DOVE CREEK SUBDIVISION
 P.O.A.D.P. # 238-B
 (REVISED)

P.U.D. PLAN
DOVE CANYON SUBDIVISION, P.U.D.
 BEXAR COUNTY, TEXAS

Re: Dove Creek (Amendment)

MDP# 238-B

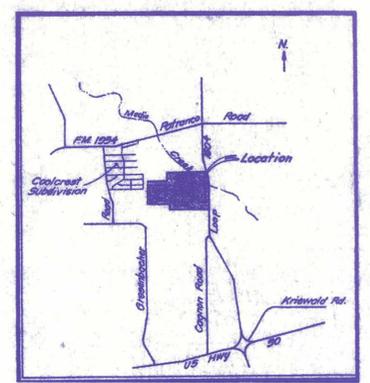
THE AMENDED AREA IDENTIFIED BY THE CLOUD IS THE RESULT OF A CHANGE IN LAND USE.
